PRODUCT/PROCESS CHANGE NOTICE (PCN)

PCN #: TB-0609-02 Product Affected: SOJ 28L, 32L, 36L Products shipped in tube Date Effective: 06-Jan-2007	DATE: 06-Oct-2006	MEANS OF DISTINGUISHING CHANGED DEVICES: <input type="checkbox"/> Product Mark <input type="checkbox"/> Back Mark <input type="checkbox"/> Date Code <input checked="" type="checkbox"/> Other
--	--------------------------	---

ATTACHMENT I - PCN #: TB-0609-02

TITLE:	PB/PBG 28/32/36 SHIPPING TUBE	DRAWING NO.	MSC-3026	REV	14
STOCK NO.	P1-069-000	DRAWING NO.	MSC-3026	REV	14
CHECKED		SCALE	N/A	SIZE	B
APPROVALS		DATE			
FILE: MSC1701	DO NOT SCALE DRAWING	SHEET	1	OF	1

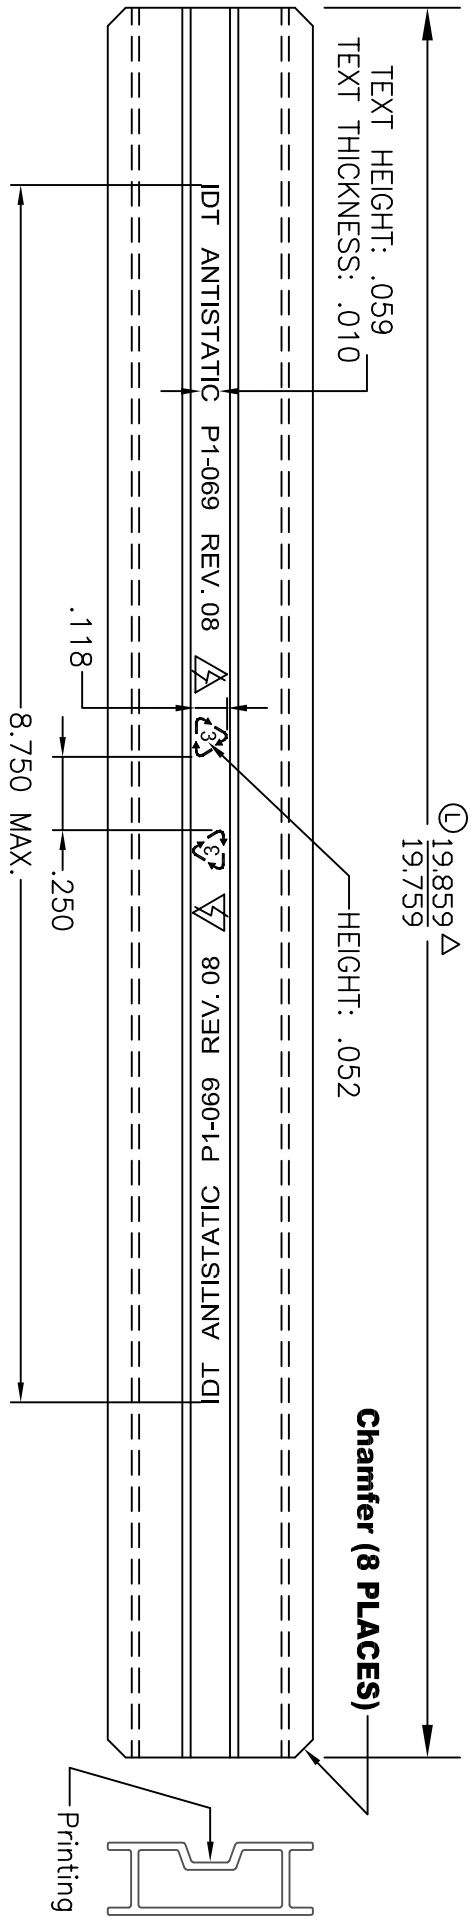
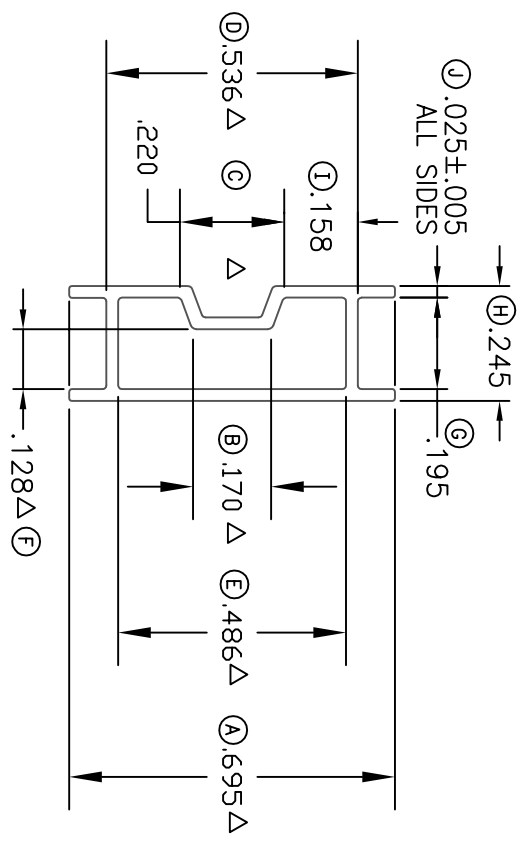
Detail of Change: This notification is to advise our customer that IDT has qualified new shipping tubes for SOJ 28L, 32L, 36L products. The new shipping tubes have an increase in the tube opening height from 0.105 inches to 0.128 inches to provide better protection for packages during assembly, test and backend processes.

** Note: Tube opening height is denoted as dimension 'F' in the tube drawing. See attachment for the drawing.*

REVISIONS				
REV	DESCRIPTION	DATE	APPROVED	
13	INCLUDED ITW MERITEX AS SUPPLIER	03/11/06	KK Three	
14	INCREASE (F) FROM 0.105" TO 0.128"	08/24/06	KK Three
